PLAN COMMISSION MEETING AGENDA

**TUESDAY, March 22, 2016
 AT 6:00 PM**

PROJECT: Plan Review – Drexel Partners, LLC

STAFF RECOMMENDATION: That the Plan Commission approves the site and building plans submitted by Drexel Partners, LLC, for the property at 600 W. Drexel Ave., with the following conditions:

SHEET NUMBER:
110

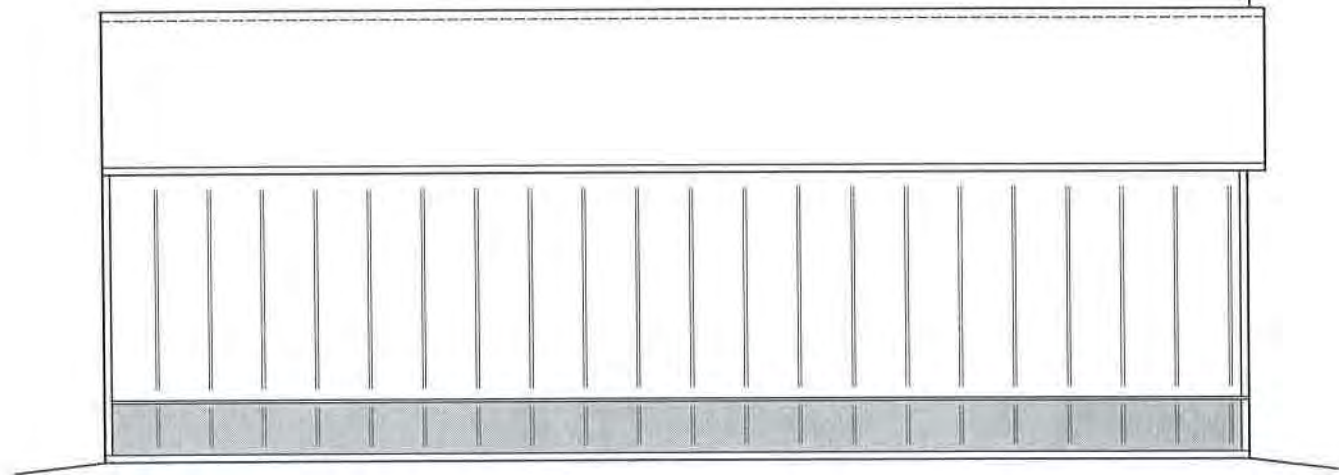
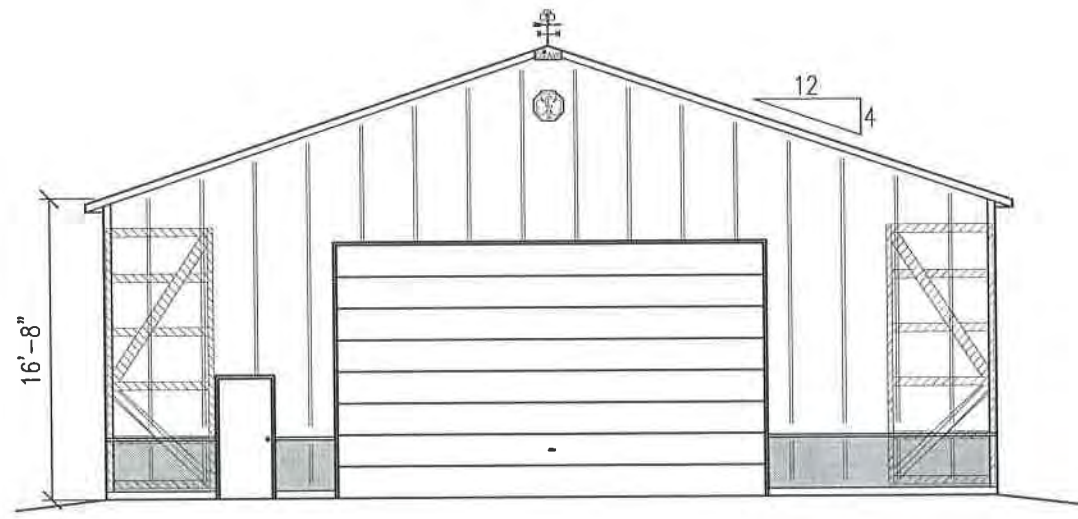
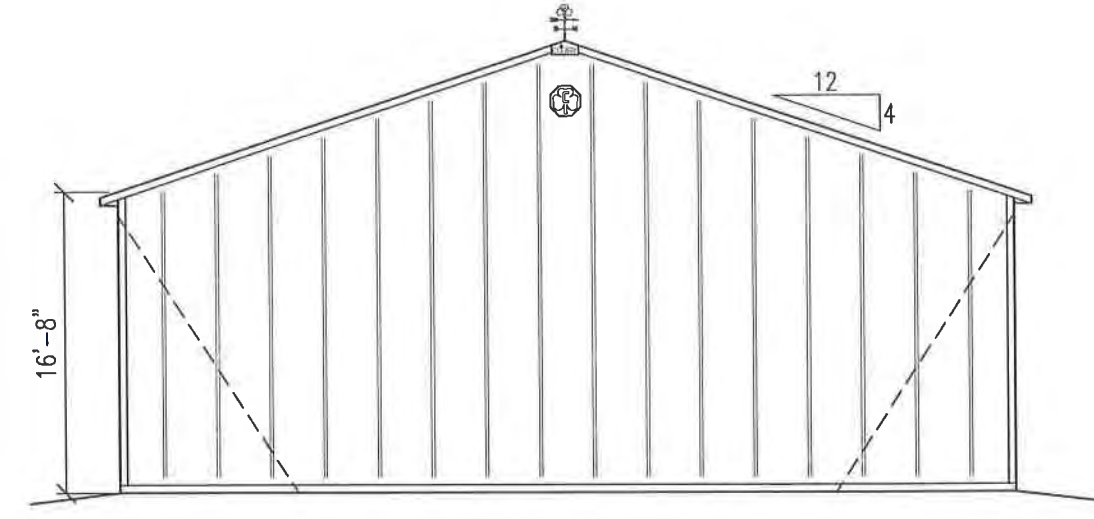
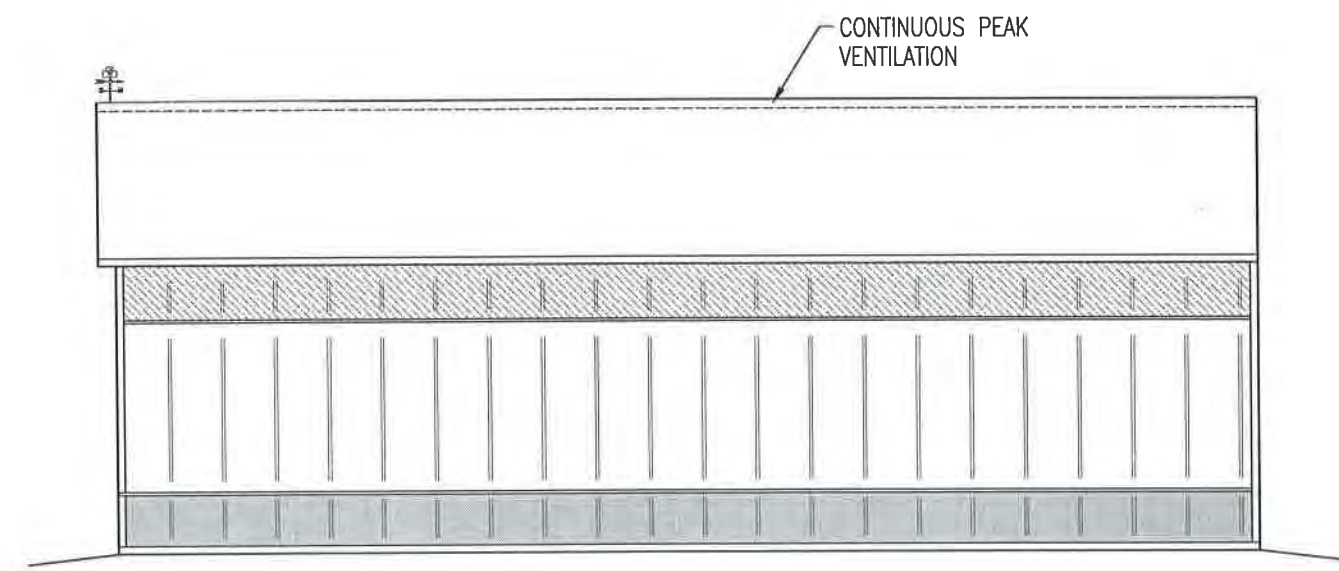
The cold storage building will be 50'x64'8" (3,200 square feet) and have a height of 25 feet. The principle exterior material of the building will be metal, which requires a ¾ majority Plan Commission approval to waive the architectural standards for a manufacturing building. The walls of the structure will consist of light stone colored steel panels with a 2.5-foot dark brown painted wainscoting along the base of the building on the north, west, and south elevations. These colors match the existing accessory structures and home. The south elevation will slightly vary from the other elevations due to a clear eavelite material just below the roof to allow for natural light to illuminate the interior. The roof will be cocoa brown which matches the roof color of the other existing buildings.
